RE: **Lot 34 Block 6, Volcano Cliffs, Unit 18, SAD 228  
6605 Sujeto NW  
Grading and Drainage Plan  
Engineers Stamp Date 7/19/19 (D10D003M34)**

Based upon the information provided in your submittal received 7/19/19, this plan is approved for Grading Permit.

ENGINEER'S SEAL	LOT 34 BK 6 U 18 VOLCANO CLIFFS SUB. 6605 SUJETO NW	DRAWN BY DEM
DAVID SOULE NEW MEXICO REGISTERED PROFESSIONAL ENGINEER 7/19/19		DATE 7-19-19
	GRADING AND DRAINAGE PLAN	LOT 34 BK 6 U 18 VOLCANO CLIFFS SUB.
		SHEET # C1
		JOB #

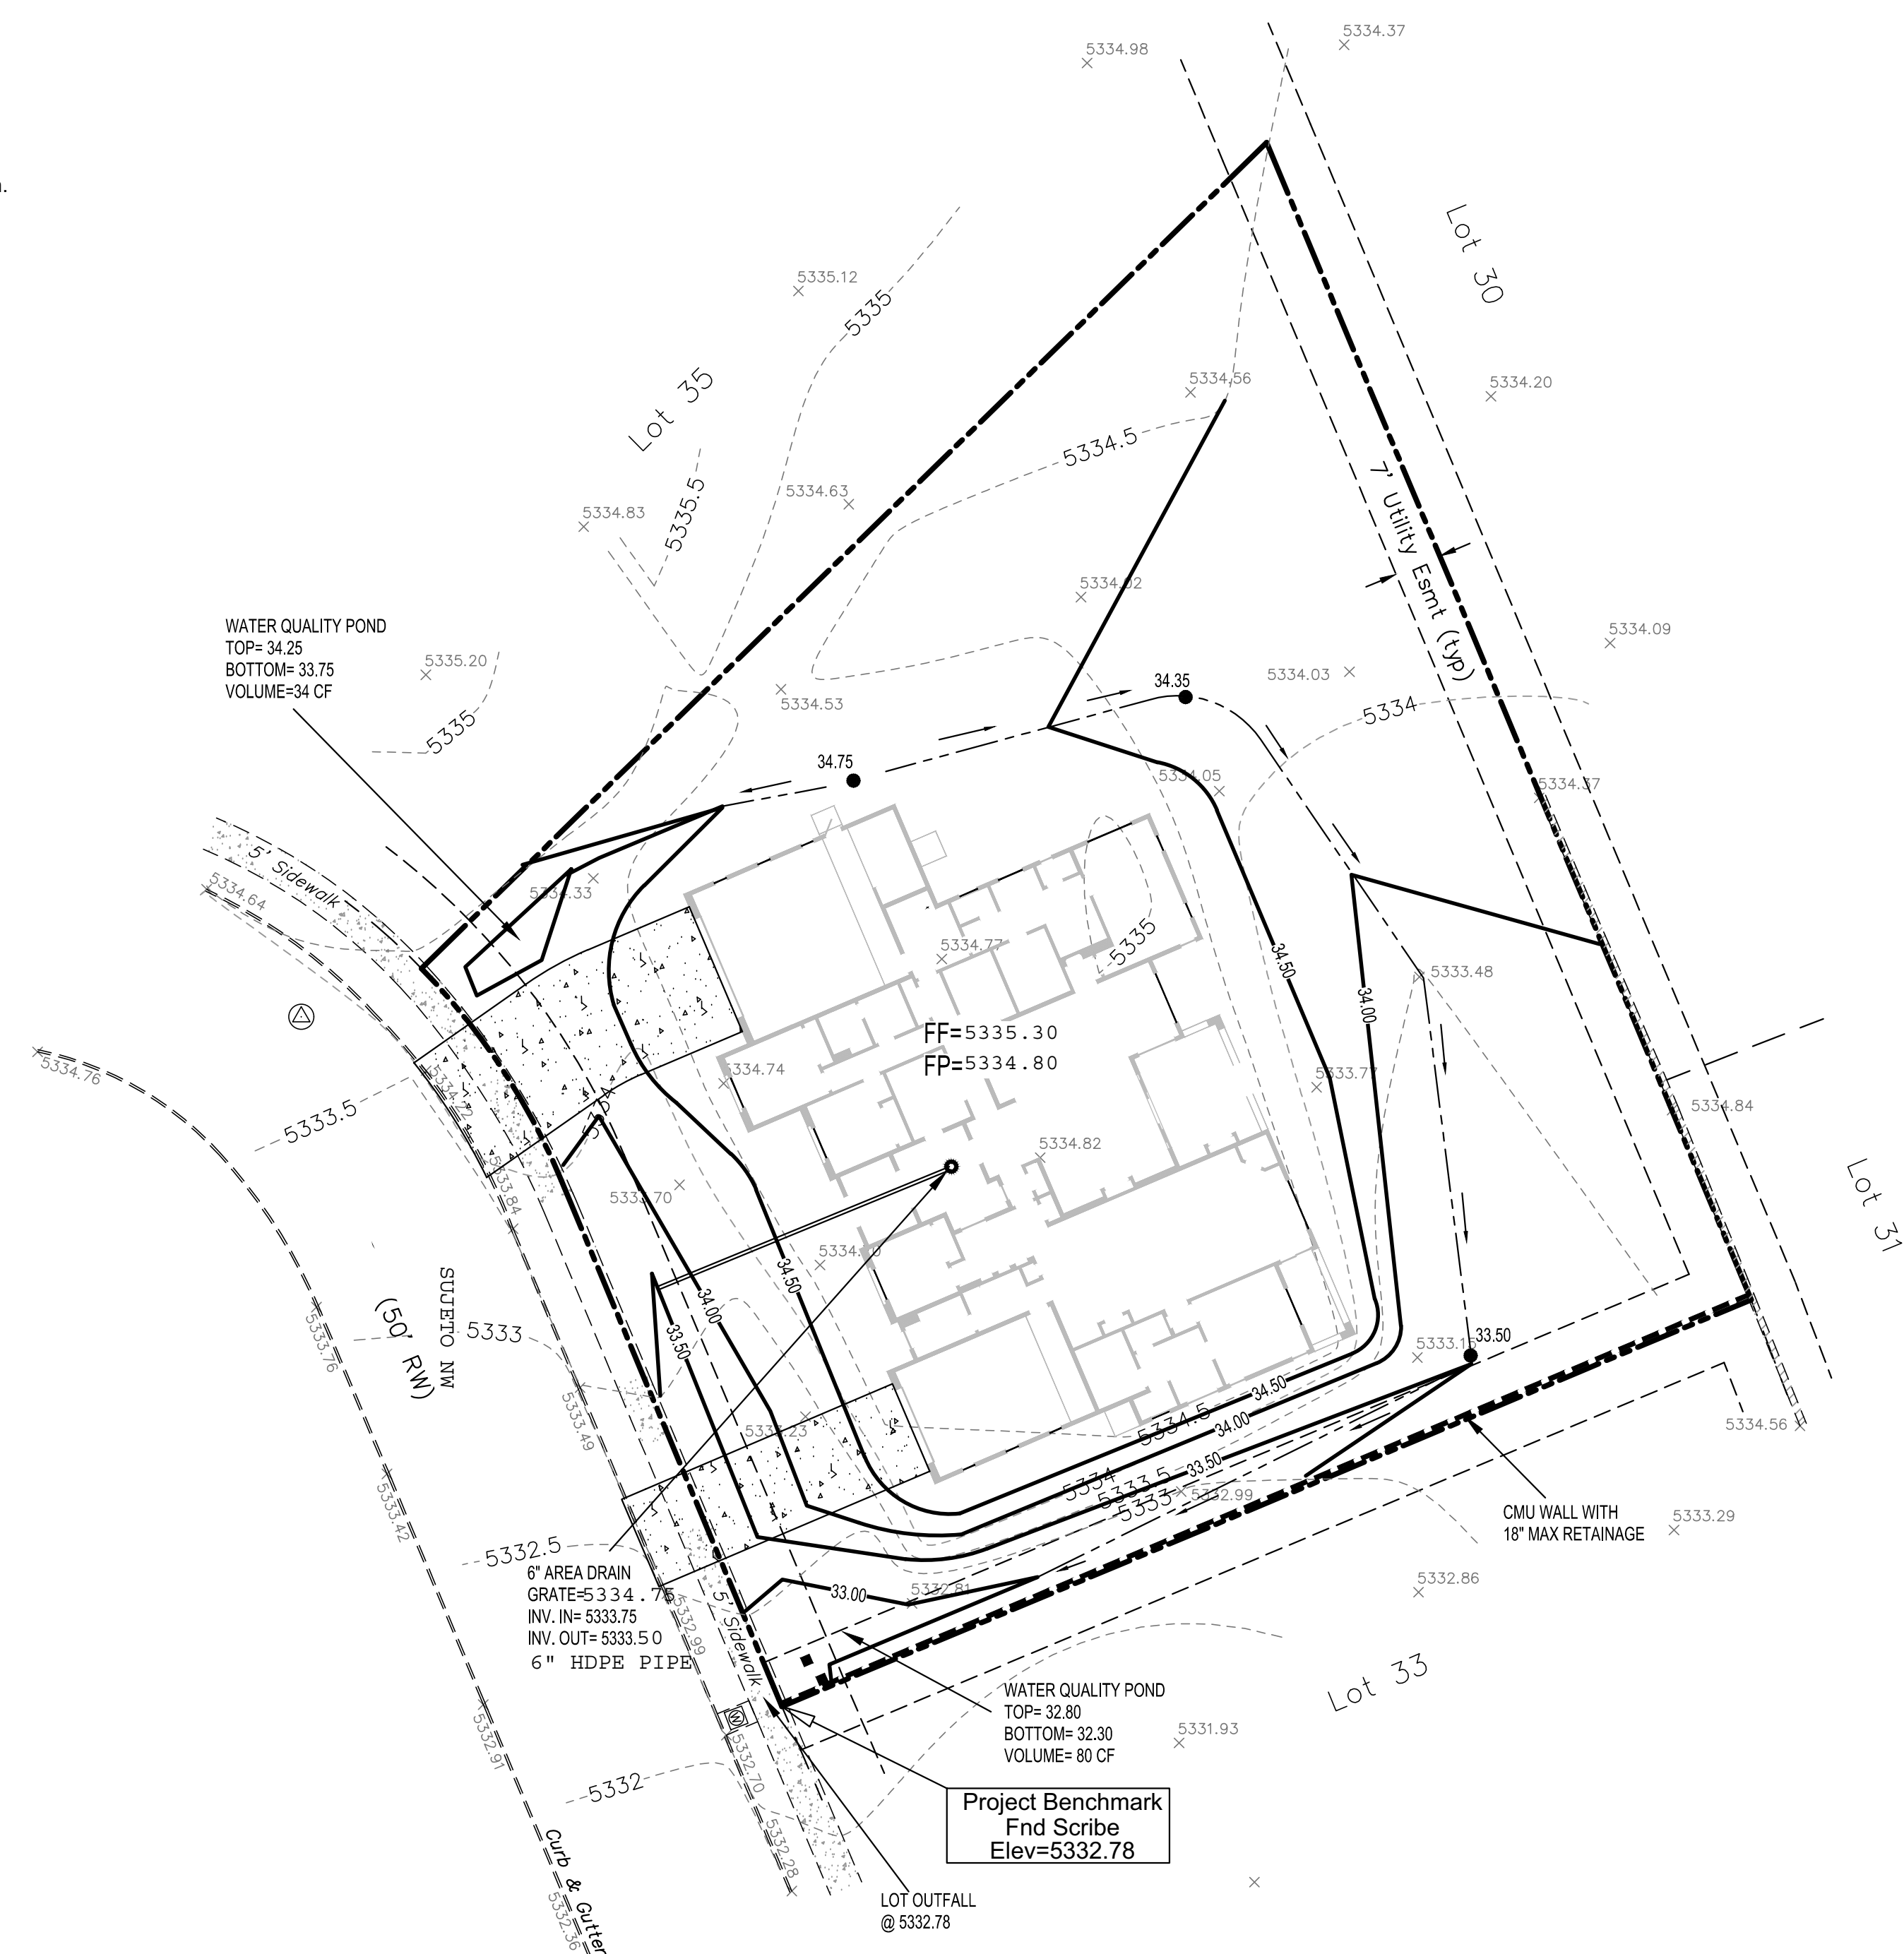
**Prior to Building permit approval a Pad Certification will be required, provided by the Engineer or a registered Land Surveyor.**

Reiterate to the Owner/Contractor that a separate permit for a garden/retaining wall must be obtained with the approved G&D plan and Pad Certification.

**Prior to Certificate of Occupancy release, Engineer Certification per the DPM checklist is required.**
